Access Compliance Report

Public Rights-of-Way

Intersection ID: 10034609	Main Street: PLANTATION_CENTER_DR	Cross Street: N/A	Location: NW
ADA ID: 91AA87B9BD04	Ramp Type: Para	Initial Pass/Fail: Fail	Overall Compliance: No
Severity Score: 13.75			
Codes/Mitigation Info/Possible Solution		Field Measurements/Component Compliance

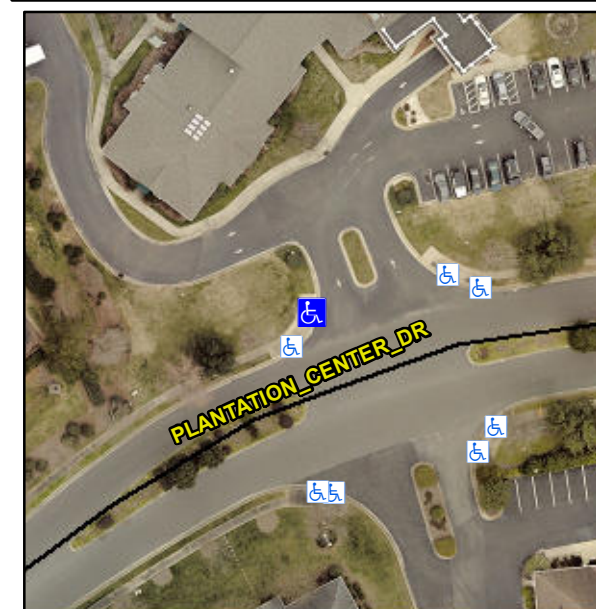
R304.5.3, R304.3.2

Compliance	Description	Data	Compliance	Description	Data
N/A	Ramp Length LT (in)	59.0	N/A	Ramp Length RT (in)	53.0
Yes	Ramp Width LT (in)	96.0	Yes	Ramp Width RT (in)	96.0
Yes	Ramp Slope LT (%)	4.8	No	Ramp Slope RT (%)	10.1
No	Ramp XSlope LT (%)	2.4	No	Ramp XSlope RT (%)	2.4
N/A	Landing Length (in)	N/A	N/A	DWS Provided?	N/A
N/A	Landing Width (in)	N/A	N/A	DWS Contrast?	N/A
N/A	Landing Slope (%)	N/A	N/A	DWS Length (in)	N/A
N/A	Landing X Slope (%)	N/A	N/A	DWS Full Width?	N/A
N/A	Landing Curb? (Y/N)	N/A	N/A	DWS Offset (in)	N/A
N/A	Shared Landing?	N/A			
N/A	Gutter Ponding?	N/A	N/A	Gutter Slope (%)	N/A
N/A	Gutter Lip Ht (in)	N/A	N/A	Gutter X Slope (%)	N/A
N/A	Painted X Walk1?	No	N/A	Painted X Walk2?	N/A
	X Walk 1 Direction	To NE		X Walk 2 Direction	N/A
N/A	X Walk 1 Width (in)	N/A	N/A	X Walk 2 Width (in)	N/A
	X Walk 1 Slope (%)	1.1		X Walk 2 Slope (%)	N/A
	X Walk 1 X Slope (%)	3.1		X Walk 2 X Slope (%)	N/A
N/A	Ramp inside XWalk1?	N/A	N/A	Ramp inside XWalk2?	N/A

Remove & Replace Entire Ramp.
